ADDENDUM #1

DATED: DECEMBER 23, 2025

**PROJECT: New Fleet Management Building for AIDT
Montgomery, Alabama**

PH&J No: 2502GVA

ADDENDUM NO. - 1
ATTACHMENT #1
M1.1
© PH&J ARCHITECTS, INC. ALL RIGHTS RESERVED.

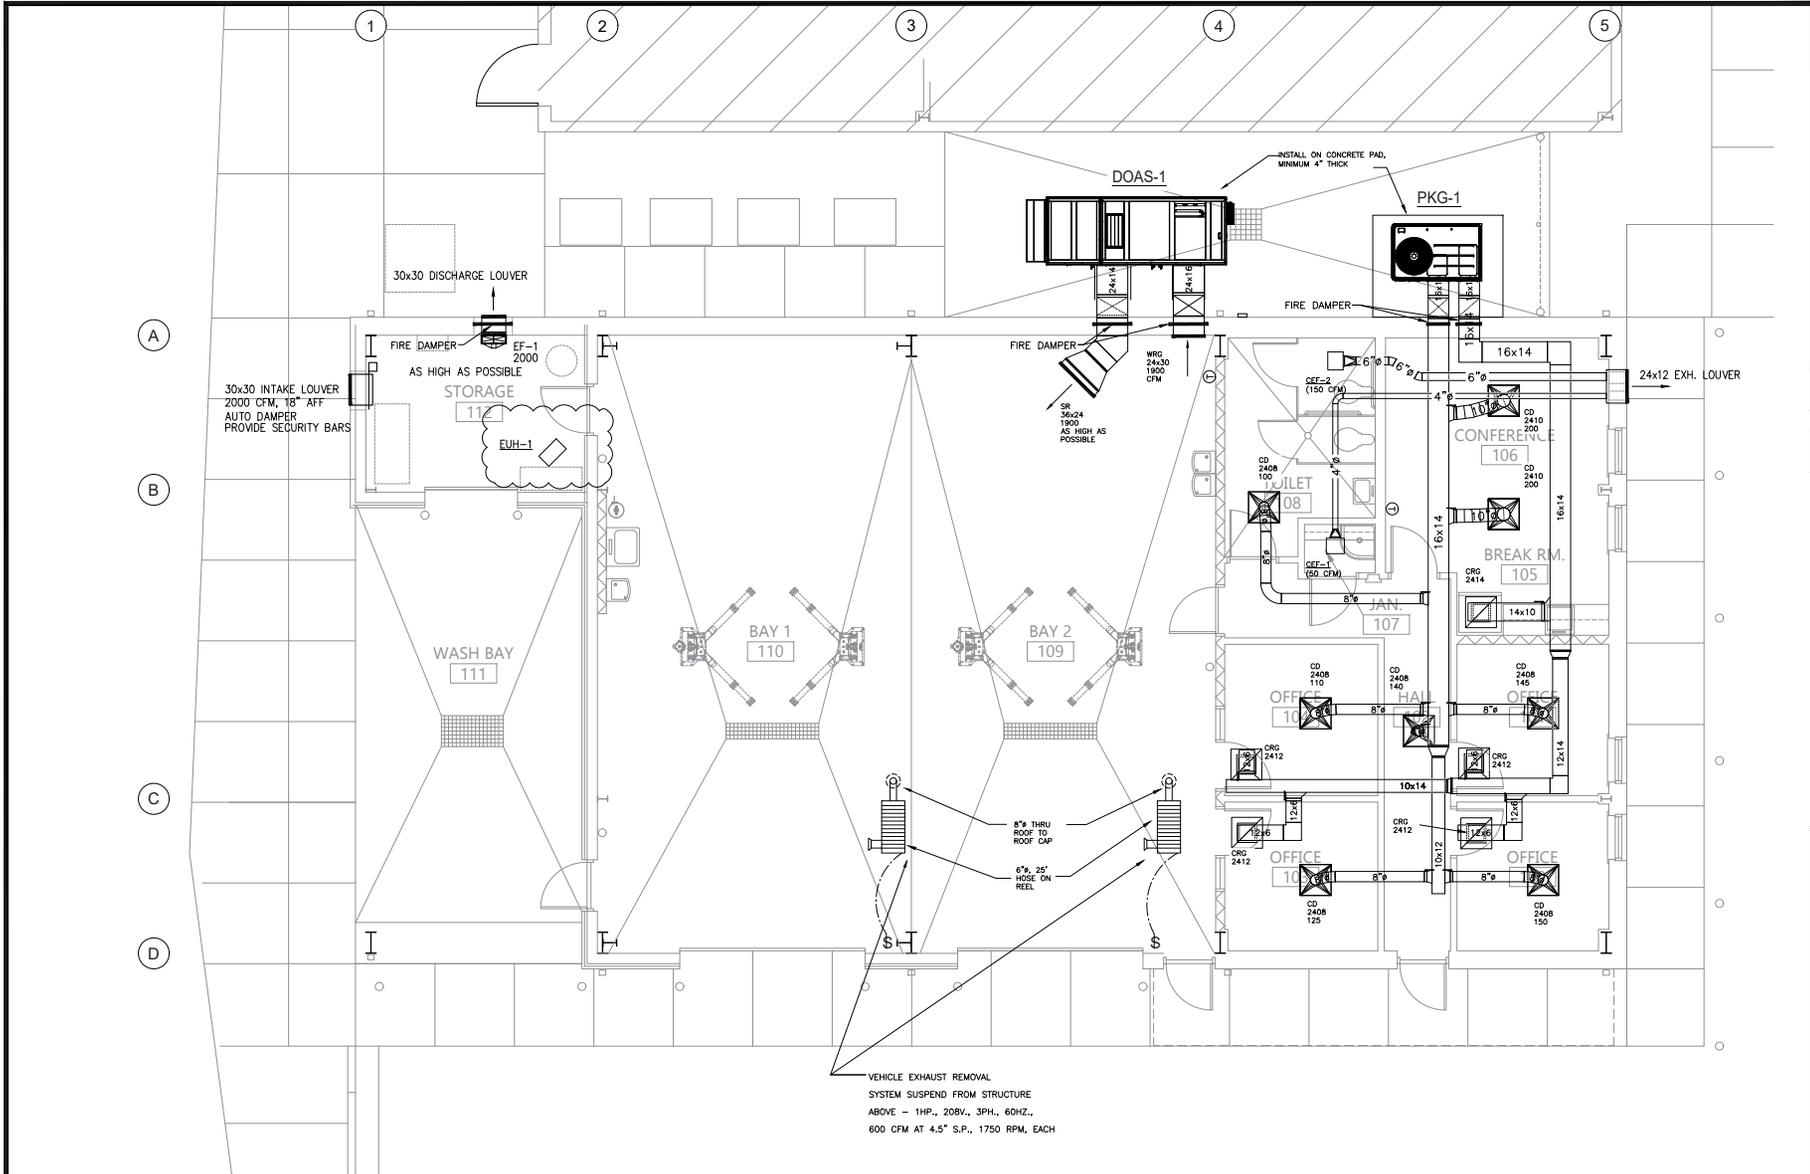
1. **Electric Unit Heater** (Drawing M1.1): Provide electric unit heater in location shown on Attachment No. 1 (EUH scheduled on sheet M2.1).
2. **Scheduled HVAC Unit "DOS-1"** (Drawing M2.2): Add additional note to scheduled unit shown on Attachment No. 2.
3. **Power Plan** (Drawing E3.1): Change all designated home run circuits from "RP1" to "SE".
4. **Mechanical Power Plan** (Drawing E3.2): Add electric unit heater to mechanical power plan and "General Equipment Schedule" as shown on Attachment No. 3.
5. **Panelboard Schedule** (Drawing E5.2): Add additional circuit and load to schedule as shown on Attachment No. 4.
